**DESIGN RECOMMENDATION  
MEETING- NORTHEAST DRB**

APRIL 15, 2019

UNION BAY PLACE APARTMENTS

SDCI PROJECT #3030253

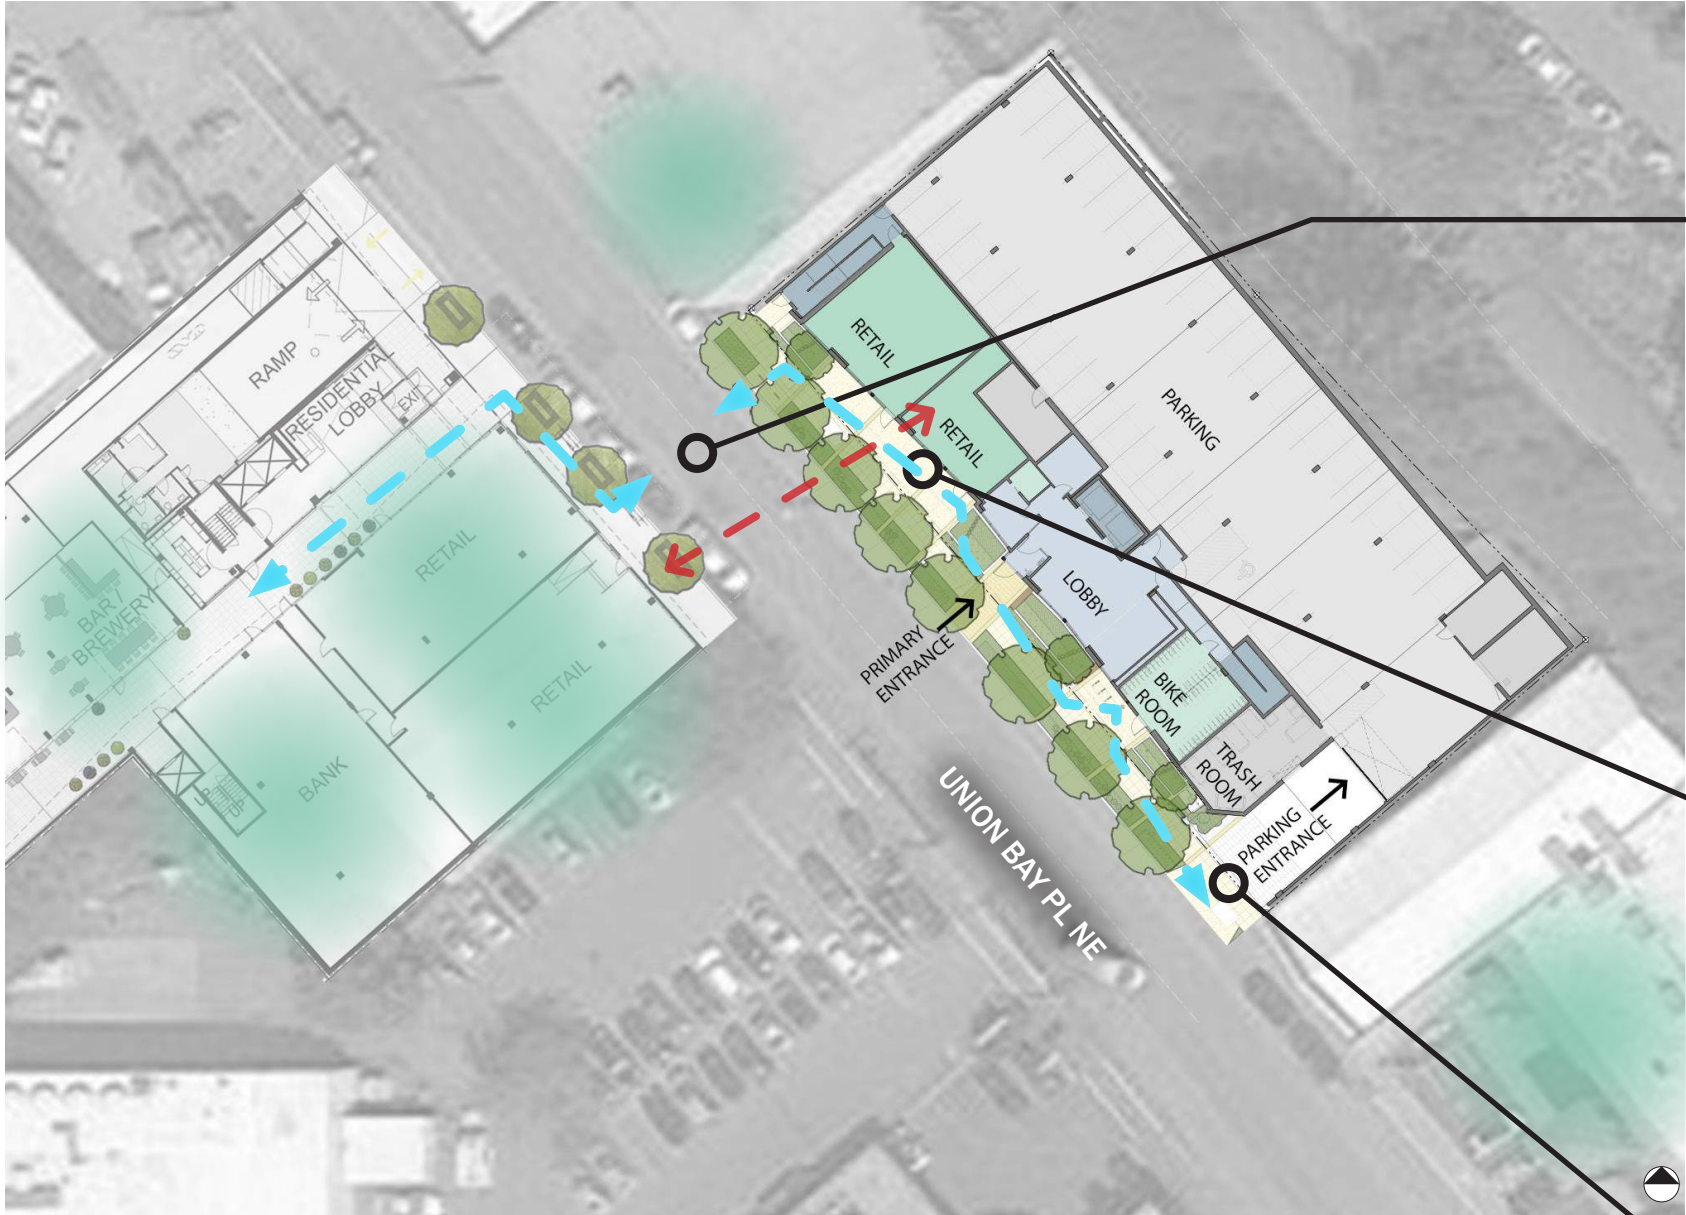
The proposed ground floor of the preferred Option D included retail at the north end of the frontage, residential lobby at the center, and bicycle room, trash room and garage entry at the south (pp. 27) fronting Union Bay PI NE. In support of this configuration, the packet included analyses depicting adjacent existing and pending curb cuts (pp. 19), adjacent existing and pending retail access (p. 46), and the proposed bicycle storage room and solid waste (pp. 47). The Board appreciated these analyses, agreeing that Option D offered the most successful ground floor plan response and recommended further development of this Option D ground floor. Pedestrian and vehicle interactions should be carefully considered. (PL3-C Retail Edges, DC1-A Arrangement of Interior Uses)

**As directed by the board, the uses within the project are oriented towards the new development across the street at 4609 Union Bay Place NE (#3020320-LU) in an effort to begin the connection of Union Bay Place NE as a pedestrian friendly, commercially vibrant, corridor. The form of the building sets back from the right of way providing ample space for healthy street trees, and planting strip to provide a layer of separation between the pedestrian users and Union Bay Place NE which is a busy vehicular connector street.**

**Additionally, the setback provides a generous angled open space in front of the retail areas for seating as well as commercial display area providing a space for people to linger and gather in (PL3-C Retail Edges, DC1-A-2 Gathering Places.)**

**Proceeding southward, the setback narrows slightly but the planting and protection continues along the street frontage, transitioning to quieter rain garden and bench seating areas outside the leasing lobby and bike room with public bike repair station and bike parking hoops (DC1-A Arrangement of Interior Uses.)**

**Finally, the driveway is located to have the least impact on pedestrian related uses along the frontage. Note that the alley access is not buildable and therefore the drive must be from Union Bay Place NE. (SDOT /SDCI have approved the exemption from alley improvement.)**

1.c.

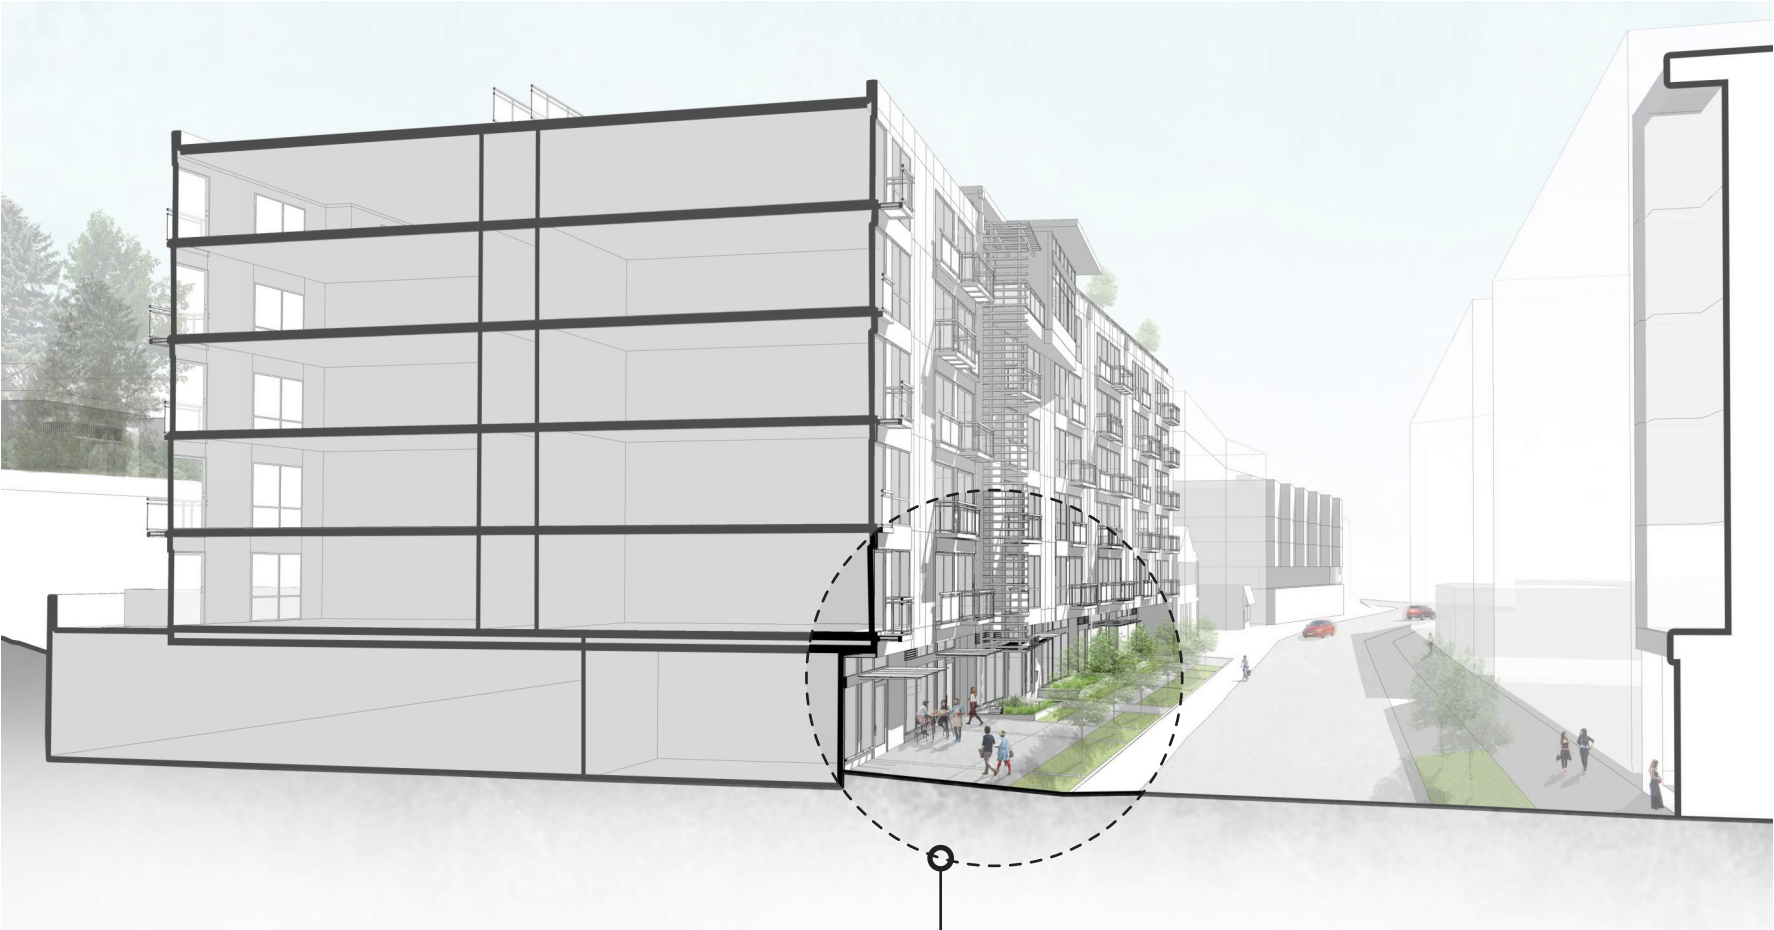
The combination of the massing bend in the west elevation and the ground floor plan of the preferred Option D resulted in an extended sidewalk condition ranging in width of 6 to 12 feet. The Board supported this ground level condition, agreeing with public comment that creating space at the right-of-way was important and will encourage activation and enhance the pedestrian experience. The Board supported the preferred Option D, finding it enhances the public realm along Union Bay Pl NE, and recommended further development of this space to allow for activities such as benches and facilitate pedestrian interaction. Include in the Recommendation packet details illustrating the treatment of this space. (PL3-C Retail Edges)

As described in 1.b, the open area in front of the retail spaces are intended for moveable tables and chairs and/or commercial display and sales. This area will welcome patrons and pedestrian shoppers (PL3-C Retail Edges). Meanwhile the area in front of the lobby and bike room are designed to be more quiet with large rain garden planters that integrate two large benches just out of the flow of foot traffic, surrounded by low planting and partially weather protected. One of the benches is adjacent to building entry where someone may await a car service or set down a bag to access the front door and speak to a pedestrian who chooses that space to pause at. The other bench is adjacent to the public bicycle repair station again providing interaction opportunities (PL1-B-3 Pedestrian Amenities, PL4-B-2 Bike Facilities)

The bioretention, rain garden, planters serve two separate project needs in an attractive way. They serve the city’s requirement to treat the water collected at the roof and provide a lush green feature creating another layer of semi-screening between pedestrians and internal users (DC1-A-1 Visibility.) They become a feature with the full height rain leaders emptying into them and help to tell the story of the site’s history in the planting types reminiscent of the Union Bay Natural Area nearby and the wood timber splash blocks harken to the history of the rail spur line serving the sawmill (CS3-B Local History and Culture). Irrigation will be provided to keep the plantings vibrant rain or shine. We also find adding signage explaining the function of the bioretention planters in the city’s ecosystem is of great interest to passers by (CS1-E-2 Adding Interest with Project Drainage.)

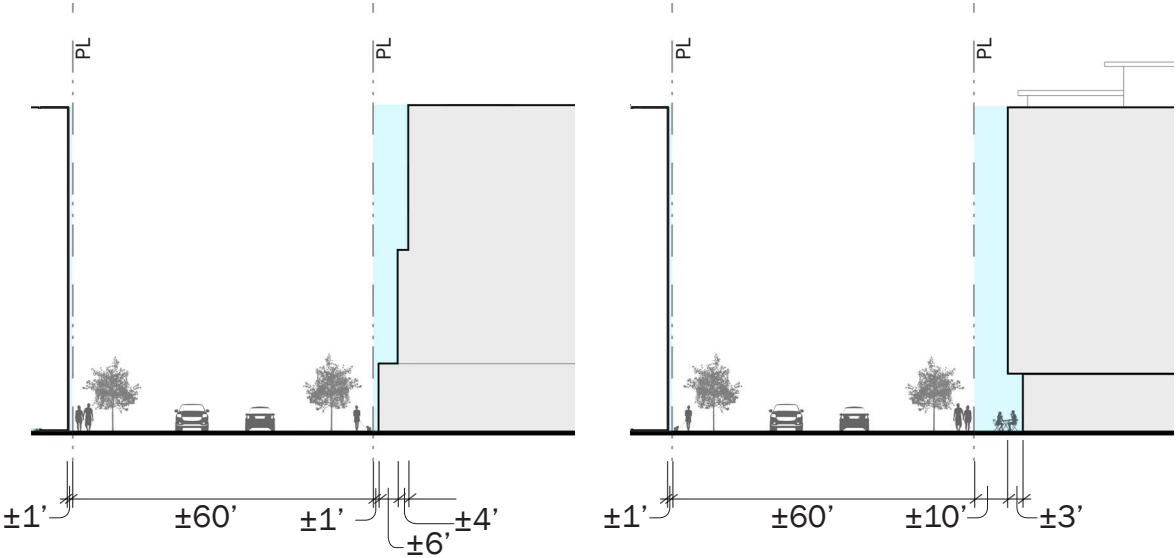
1.d.  
The Board recognized the unique street grid of the neighborhood, noting the diagonal configuration and bend of Union Bay PI NE (pp. 22-23). Due to this configuration, along with the impact of new development with increased heights along this street, the Board discussed the possibility of a tunnel or canyon effect perceivable from the public realm. The perspectives on page 32 begin to illustrate such a concept. The Board expressed concern about a canyon effect condition and agreed the massing bend and additional space at grade in preferred Option D will mitigate this condition (pp. 32-37).

**RESPONSE:**  
**1.d.**  
**The public realm is important to the life of this project and the community that it will be a part of. Although no setbacks are required in this zone, the building is setback as much as possible on this narrow parcel in an effort to provide at-grade public space, while maintaining functional retail and code required parking that are also key ingredients to a vibrant public realm. The massing fulfills a similar right of way setback to “traditional” zoning versions, but provides more space at grade for public use.**

**The high water table does not allow the parking to be located below level 1. Upper levels are coordinated with the limited locations left over for the vertical cores yet is able to set back to further enhance the amount of sun available on this south and west facing parcel. The concept was inspired by the city grid and its history but was also selected because it creates a form that supports this sunlit open space (CS2-B-1 Site Characteristics, PL2-B-1 Eyes on the Street, PL1-C-1 Selecting Activity Areas.)**

1.e.

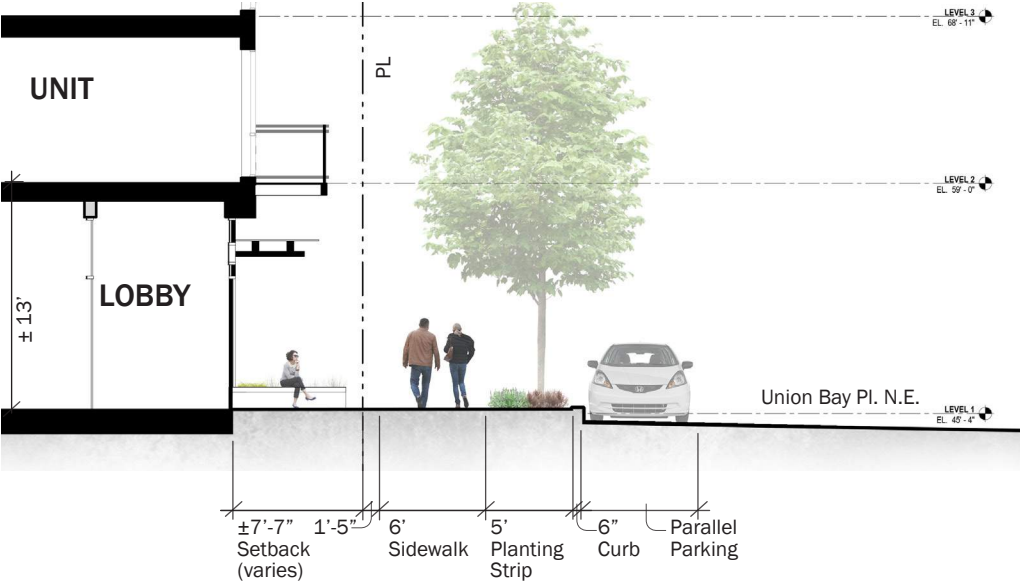
Current development along Union Bay PI NE has resulted in improvements to the right-of-way including new sidewalks. Public comment noted this condition and recommended a solution that would result in a new sidewalk for the entire length of Union Bay PI NE. The Board acknowledged this public comment, agreeing the public realm is an important consideration and that this development will contribute to the overall quality of the public realm and urban fabric of the neighborhood. The Board requested information be presented at the Recommendation meeting illustrating the treatment of the Union Bay PI NE frontage at this site. (PL3-C Retail Edges, DC3-B Open Space Uses and Activities)

See also responses to 1.a, b, c, d. & 2.a. Large sections of storefront glazing, transparent between two and eight feet above sidewalk have been provided. Open, flexible space is provided in front of the retail spaces for use as spill-out areas of seating and display. Transparency is balanced with landscape screening so that there is a connection with some sense of privacy between more sensitive residential lobby and the sidewalk (PL3-C Retail Edges, DC3-B Open Space Uses and Activities.)

Where more support uses such as the bicycle storage room and trash room are forced to the frontage by the site limitations, those frontages are also set back to provide a public bench seating area, plantings, and bike maintenance stand in addition to secured public bike parking . Weather protection is extended to some of this space as well. Blank walls for these residential support areas are provided with art panels that illustrate the historic past of the site via maps that also can be used for way finding for bicycle users and pedestrians following the rails to trails history of the Burke Gilman Trail (CS2-B-2 Connection to the Street, DC2-B-2 Bank Walls.) Locating the trash room at the frontage has the added benefit of not requiring a staging area for garbage bins/dumpsters in the open along the street. They will always be out of site within the building, further improving the pedestrian experience (PL3-C-3 Ancillary Activities.)

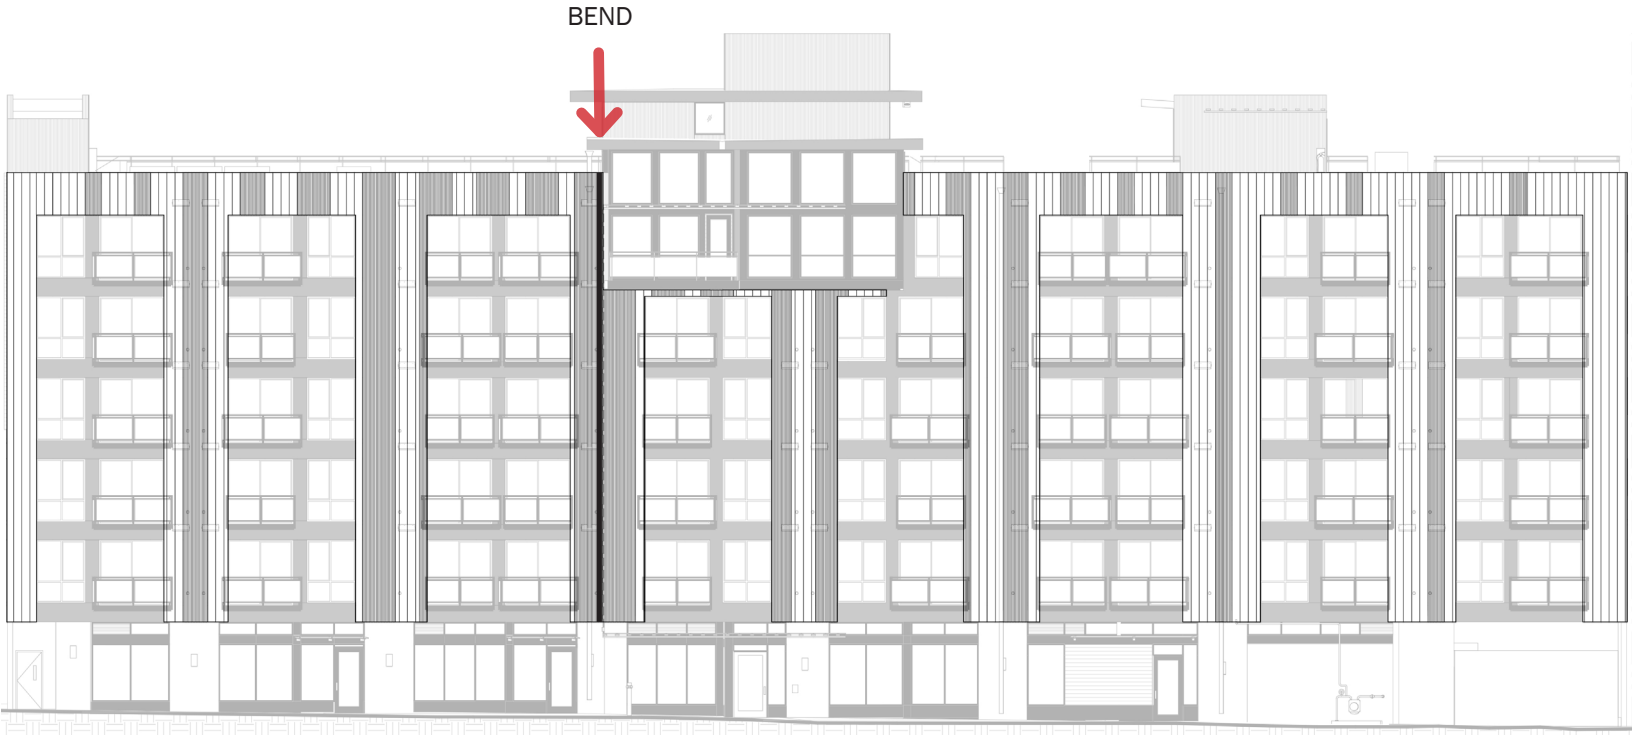
The bend in the west elevation was identified as an integral part of the architectural concept, adding an element of interest. The Board recommended attention to detail in the treatment of this bend.

The Recommendation packet (pages 20-23) contained a historic analysis of the area, outlining how this context, including the rail spur line, lumber mill on Union Bay, and area circulation patterns informed the massing. The Board appreciated this attention to detail and encouraged the project to incorporate these historic references in the architectural concept in subtle and obvious ways. (CS3.B Local History and Culture)

Translated into texture of siding  
(Example image shows random patterning that gets more dense to the right)
